# UNITED STATES PATENT AND TRADEMARK OFFICE

10/720,473

<b>Office Action Summary</b>	<b>Application No.</b> 10/720,473	<b>Applicant(s)</b> PLOOKSAWASDI, SUNTISUK	
	<b>Examiner</b> William V. Gilbert	<b>Art Unit</b> 3635

**DETAILED ACTION**

Figure 2 from Bowmer

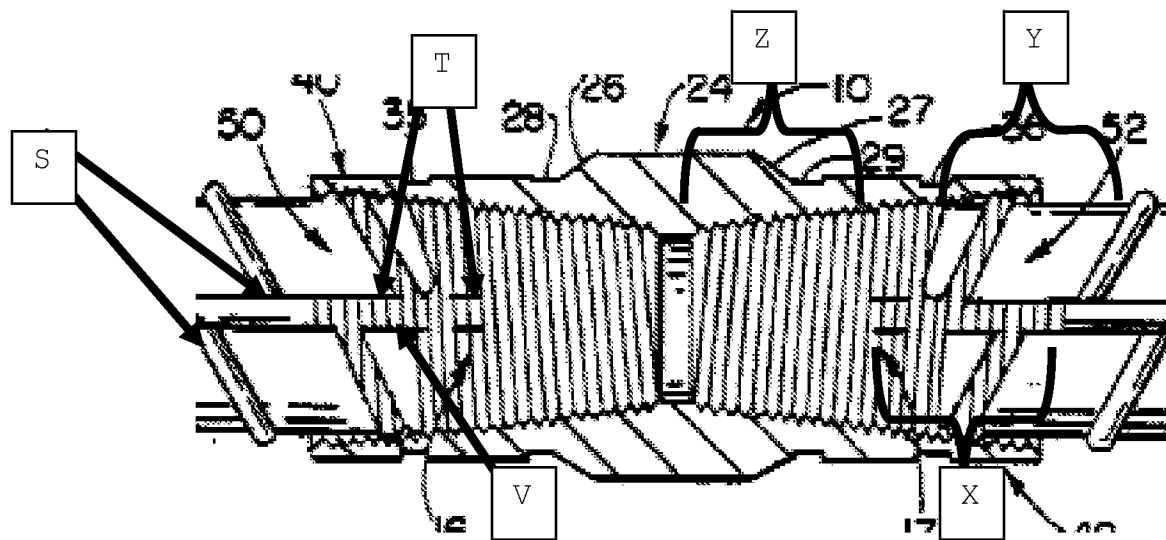
Claim 9: Bowmer discloses a threaded deformed reinforcing bar comprising a core (Fig. 2: proximate 12) and a transversely extending rib (threads, proximate 16) and at least one longitudinally extending rib (15, proximate "T" below) intersecting the transverse rib at multiple areas (see proximate 17; "X" below) and interrupting said pattern of threads along said bar in at least a first section of the bar ("Y" below) and the rib is absent from a second section ("Z" below) adjacent at least one end of the bar where the pattern of threads, which is

formed by the transverse ribs and the second section, is unobstructed, and an internally threaded member having an internal thread sized to receive the transverse ribs can be threaded onto the pattern of threads which is formed by the transverse ribs in the second section.

Claim 10: the transverse rib is a continuous spiral along the bar (it is continuous along the bracketed portion "Z" above.)

Claim 12: the transverse rib includes at least two series of discontinuities (see "V" above and where the second longitudinal rib would be located on the opposite side of the core) extending longitudinally along the bar and one longitudinal rib extends along each of the discontinuities (proximate "V".)

Claim 13: the transverse and longitudinal ribs are integral with each other and with the core (see Fig. 2, generally.)

Claim 1: Bowmer discloses a threaded deformed reinforcing bar comprising a core (12) a series of transverse ribs (16) on the core, the ribs are spaced longitudinally along the bar and separated by troughs (portion between the rib, see above) and a longitudinally extending rib (15) extending in a gap (the gap

exists between ribs; "S" from attached Fig. 2 from Bowmer, above) the longitudinal rib interrupted adjacent at least on end of the bar (as shown in Fig. 2) such that the longitudinal rib defines discontinuous sections in the troughs ("T" above), whereby an internally threaded member having an internal thread sized to receive the transverse ribs can be threaded onto the pattern of threads and the longitudinally extending rib to not comprise the pattern of threads. Bowmer does not disclose at least two series of transverse ribs. It would have been obvious at the time the invention was made to a person having ordinary skill in the art as a matter of duplication of parts to have this limitation because duplication of parts has no patentable significance unless a new and unexpected result is produced. *In re Harza*, 274 F.2d 669 (CCPA 1960). See MPEP §2144.04. Further, Bowmer does not disclose a gap in the transverse ribs. Finsterwalder discloses a reinforcing rod with a series of ribs that has a gap between the sections of transverse ribs (e.g. Fig. 4: 2). It would have been obvious at the time the invention was made to a person having ordinary skill in the art to have the gap in the ribs because the ribs are functionally equivalent and would perform equally as well. Further, the gap in the threads also aids in ease of attachment of threaded members.

Claim 5: the longitudinally extending rib is interrupted by the absence of the longitudinal ribs in the trough (as shown in Bowmer, the longitudinal rib is absent in a portion of the transverse threads indicated as "Z" above.

Figure 7 from Tani

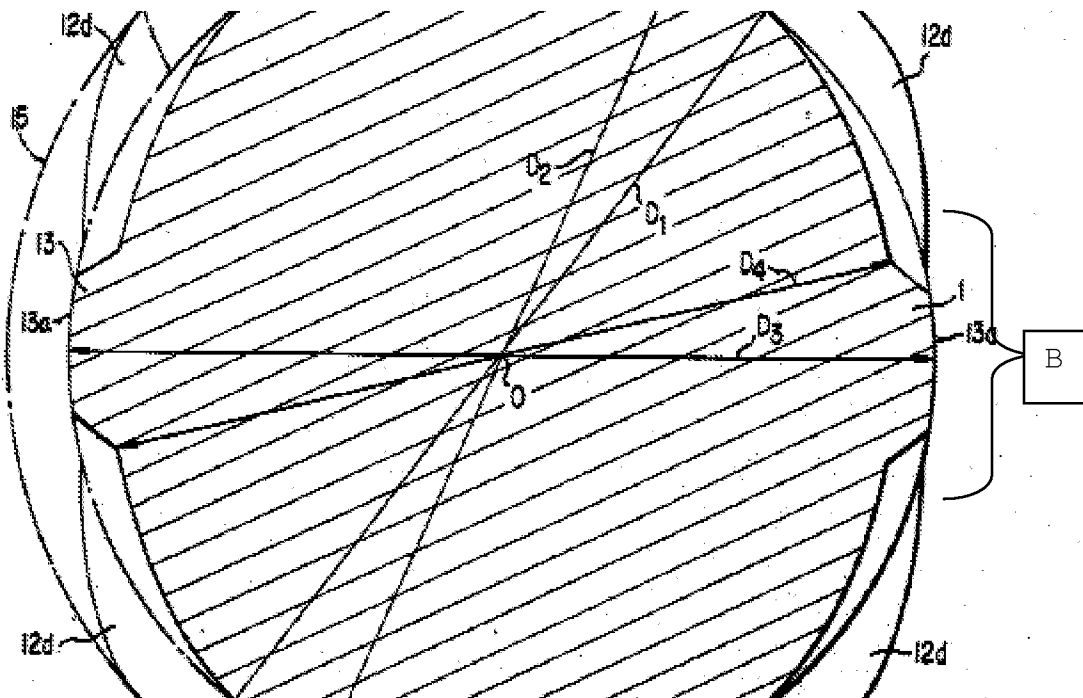
Claim 1: Tani disclose a deformed reinforcing bar to be used with concrete comprising a core (Fig. 7: 11) a series of transverse ribs (12) aligned and spaced along the bar and separated by troughs (see "A" from attached Fig. 16 from Tani, below), each series separated transversely from a adjacent series by a longitudinally extending gap (see "B" from attached Fig. 7 from Tani, below), where the series of ribs form a pattern of threads along the bar, a longitudinally extending rib (13a) in the gap, interrupted adjacent at least one end of the bar (the longitudinal rib ends where the bar ends) such that the longitudinal rib defines discontinuous sections in the troughs (see 16a generally) whereby an internally threaded member may be threaded onto the pattern of threads which is formed by the transverse ribs and the longitudinal rib does not compromise the pattern of threads. While Tani discloses a series of transverse ribs, it does not disclose at least two series of transverse ribs. It would have been obvious at the time the invention was made to a person having ordinary skill in the art as a matter of

Claim 2: the core has a substantially circular cross section. While noted that the Tani reference discloses a non-circular member, the examiner contends that as shown in the drawings, "non-circular" and "substantially circular" are synonymous.

Claim 3: the transverse ribs and longitudinal ribs are integral with each other at the intersection of the ribs (via portion 14).
